MEMORANDUM

UTAH DEPARTMENT OF TRANSPORTATION

SUBJECT: Standards Committee Meeting Minutes and Next Meeting

Standard Drawing/Specification Review Sheet			Review Comments		
Std Dwg/Spec Number	GW 3 and GW 4		Sheet 4	of	4
Date:	9/19/07		Facilitator:	Wes Starkenburg

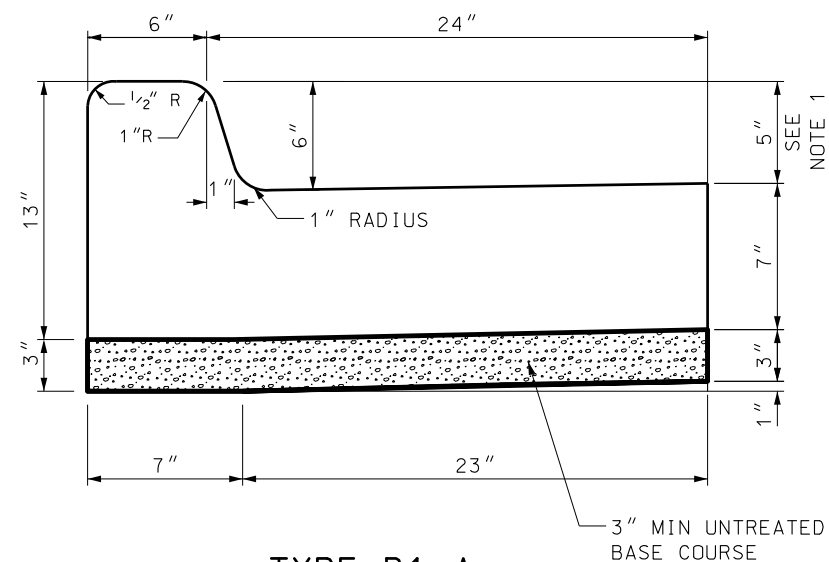
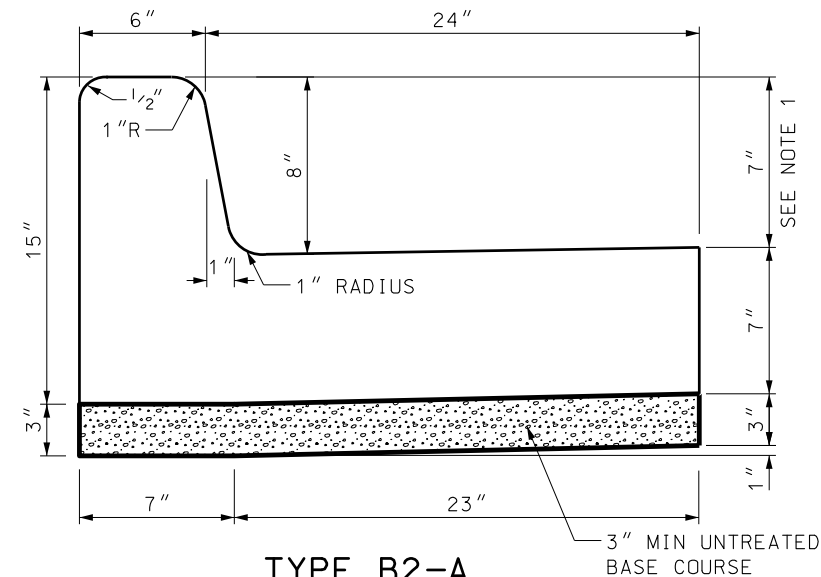
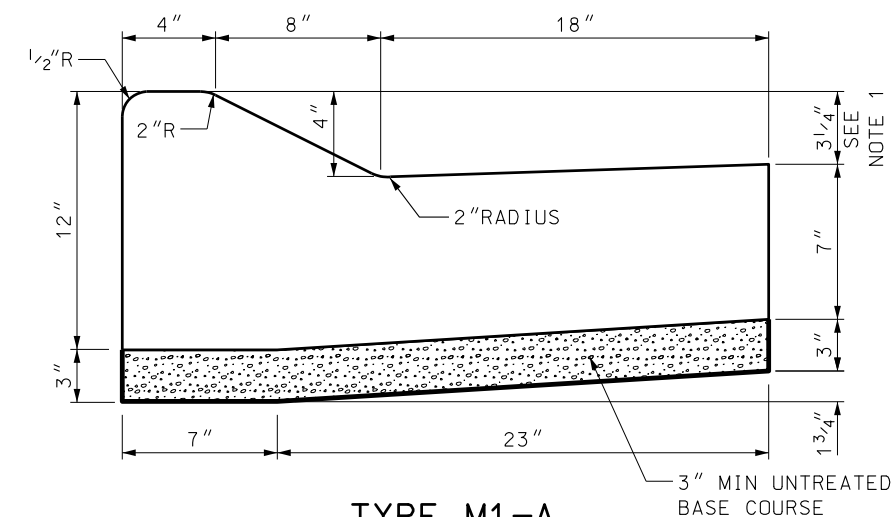
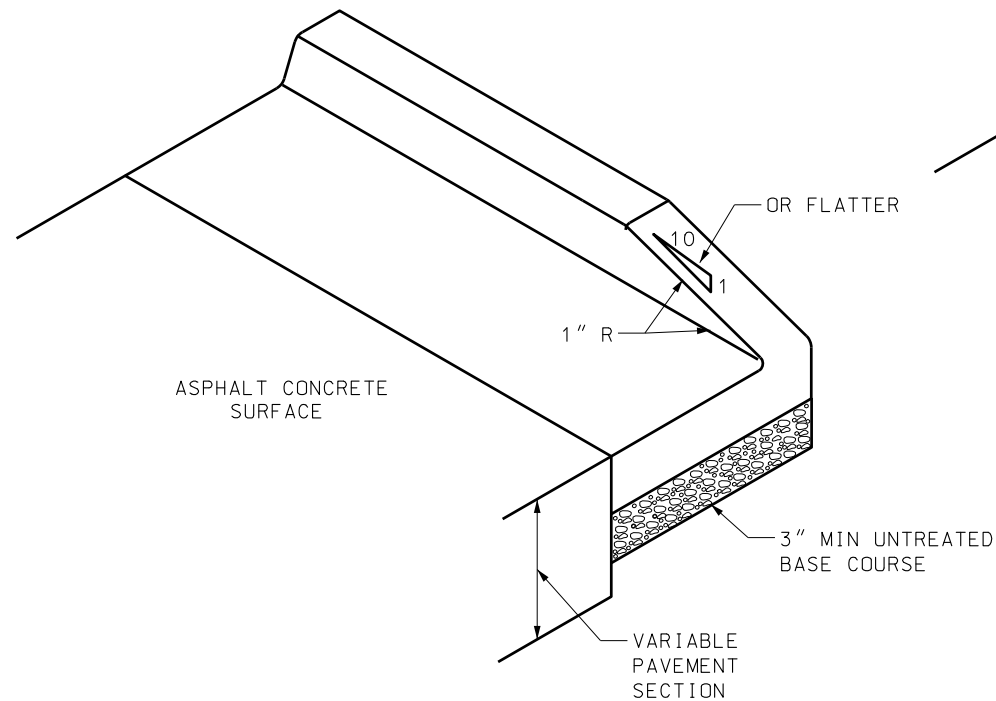
25	David Schwartz	GW 4	Are we eliminating park strip	C	C
			No

26	David Schwartz	GW 4	Re max breakover.	A	A
			Changed to read algebraic difference

27	David Schwartz	GW 4	Should drive way max slope be 12:1.	C	C
			No leave as 10:1 as before

28	Fred Jenkins	GW 4	2(AGL) yields feet not sq t	A	A
			Changed formula, shows results of calcs

30	Tim Biel	GW 3	Should read Hot Mix Asphalt	A	A
			Will correct

STANDARD WILDLIFE ESCAPE RAMP DETAIL

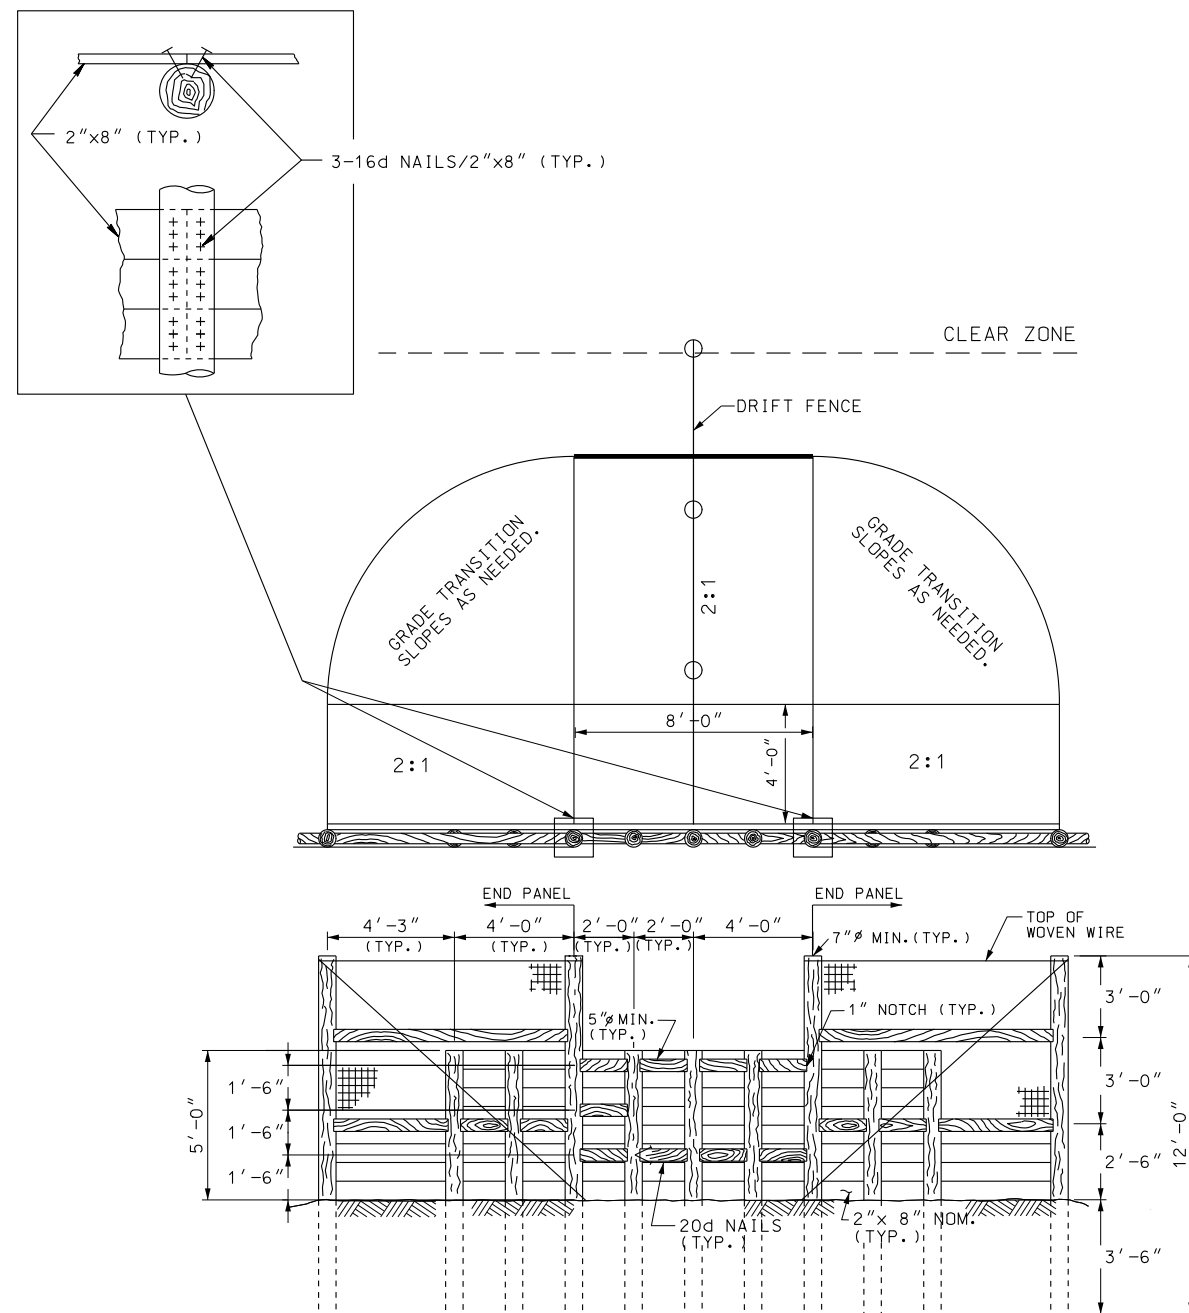
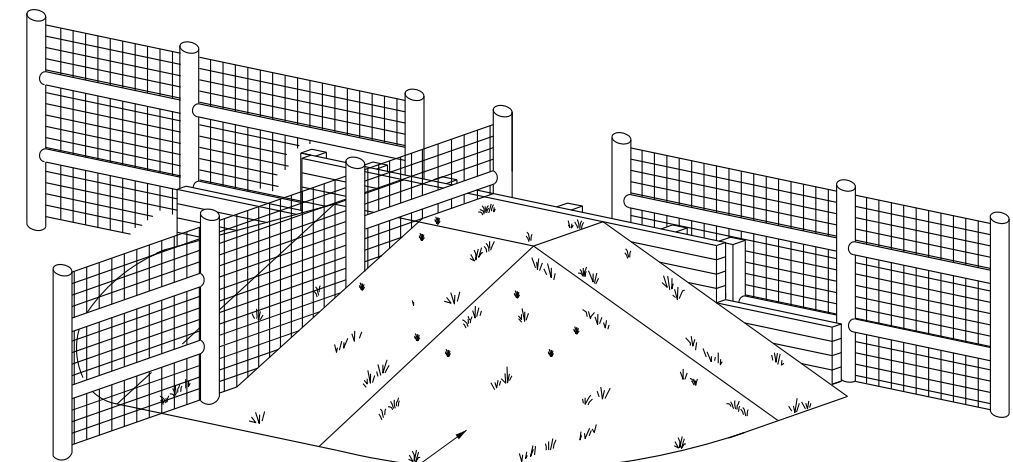
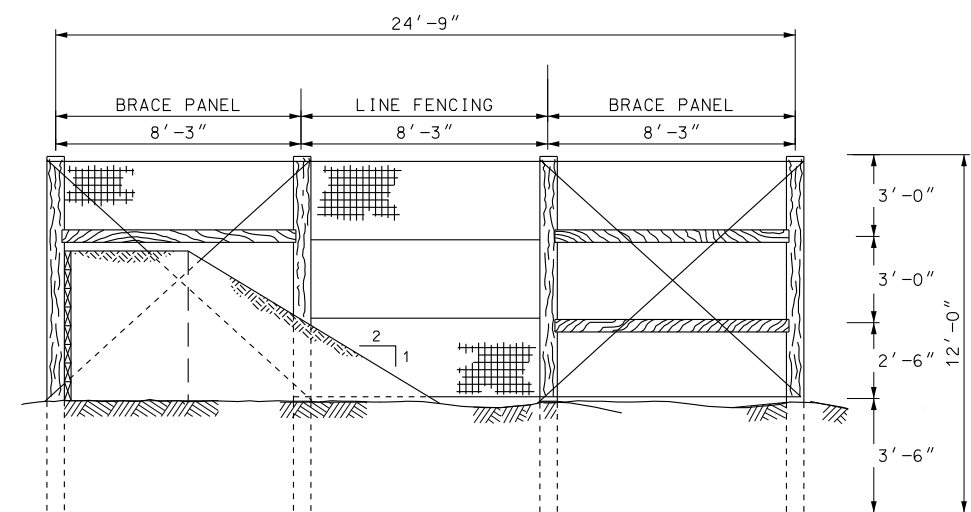
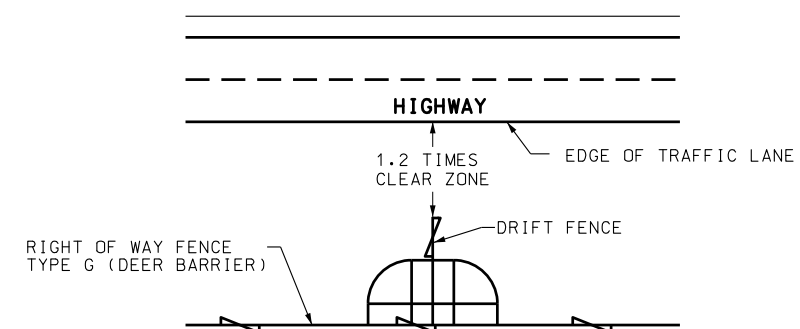
It is proposed, therefore, that figure FG 4A (Deer Crossing Details or Deer Gate) be changed to "Standard Wildlife Escape Ramp Details" and FG-4B to "High Migratory Wildlife Escape Ramp Details." These changes should clarify the purpose of these structures.

28	Clark Mackay, R-4 Eng. Mgr.		Sheet FG 4C Your drawing shows the deer fence as having wooden posts. I believe the standard is steel posts. Your isometric drawing shows the drift fence only coming out three sections. The dimension given is 100'. I would suggest a break line so as to not imply three sections on both sides.		
			Response: Drawing changed to show T-posts after brace panels Updated drawing will show break lines
